# Redtail Ranch Preliminary Plat

**Town Council**

Harry Brennan, Senior Planner

June 25<sup>th</sup>, 2024

## 1. Oil & Gas Setbacks

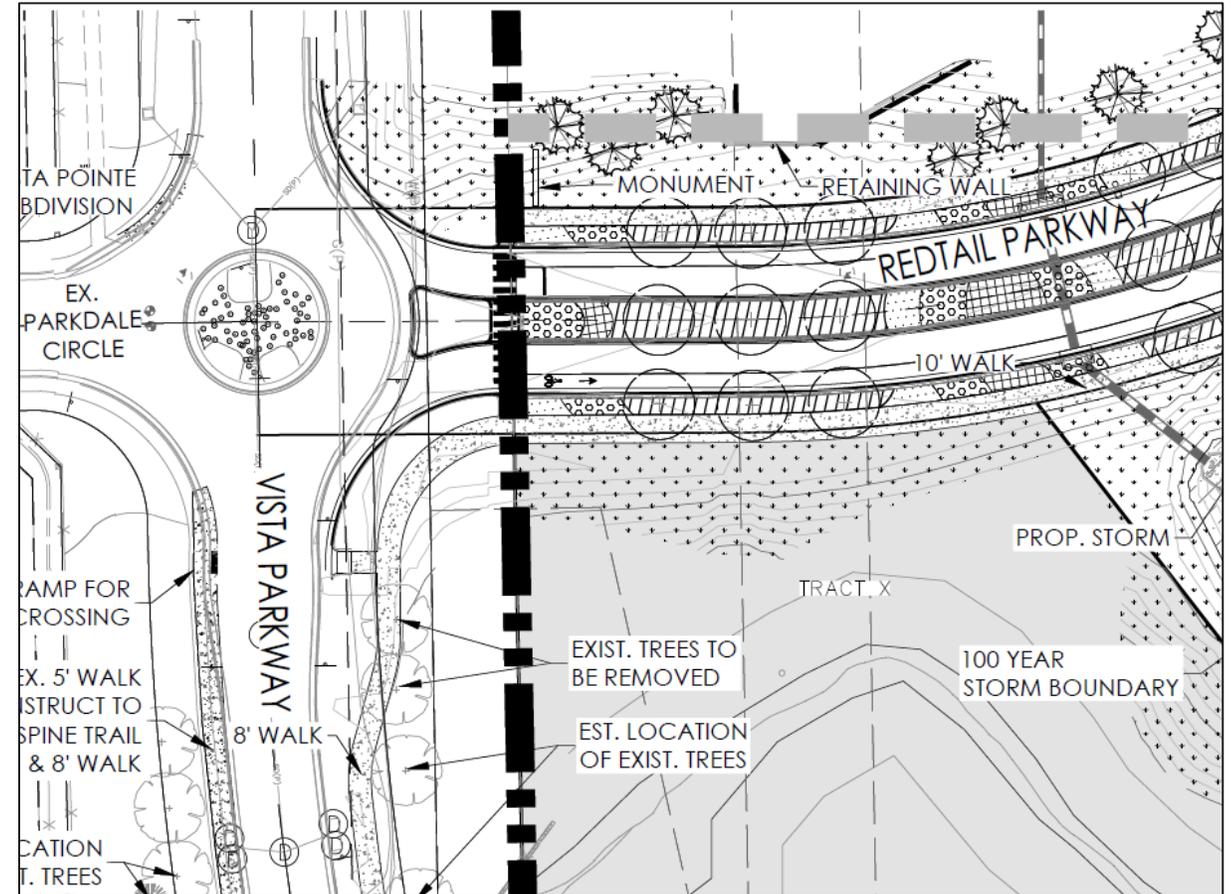
- Applicable 2021 standards for O/G require 350' buffer.
- Applicant proposes abiding by current O/G standards which require 500' buffer
- 63 lots are eliminated by abiding by the 500' O/G buffer

## 2. Traffic Impacts

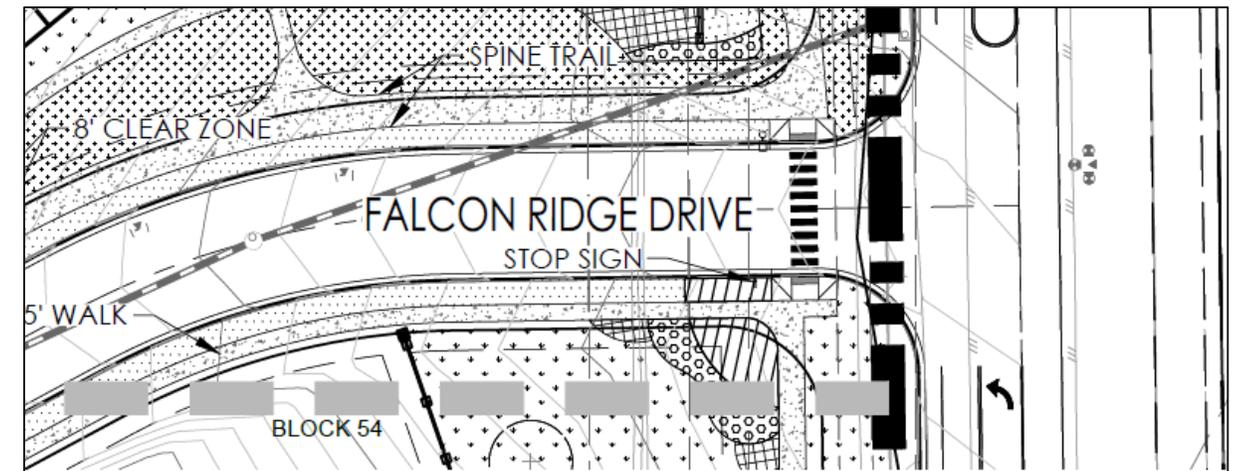
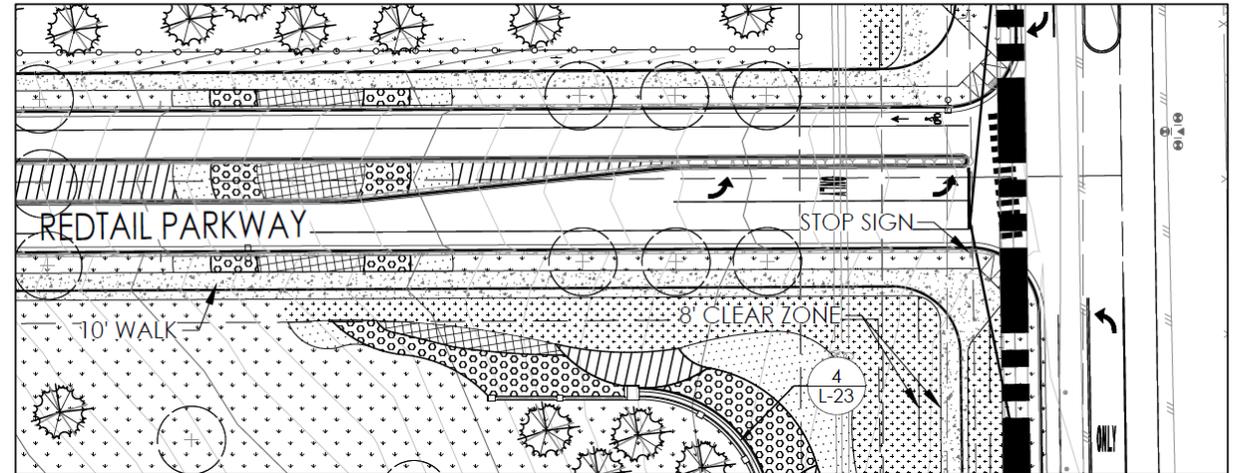
- WCR 5 – Road widening, stop sign controlled full movement access intersections. Traffic signals at Redtail Pkwy and Falcon Ridge Dr are not warranted at this time. Developer will pay fair share contribution to signals when warranted.

## 2. Traffic Impacts

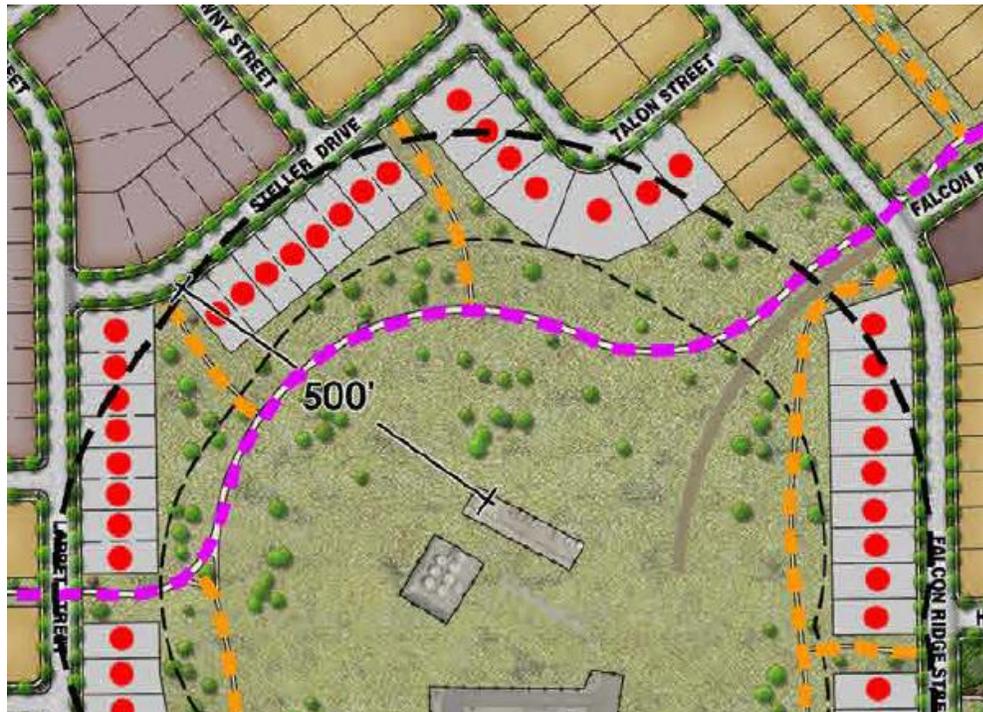
- Regional Intersections - The Town will evaluate levels of service with future land use applications in Redtail Ranch and other nearby developments to determine necessary improvements.
- Traffic Calming on Redtail Pkwy – The plans show two speed feedback signs, bike lanes and 10' travel lanes to help slow traffic. Further strategies can be explored at Final Plat.
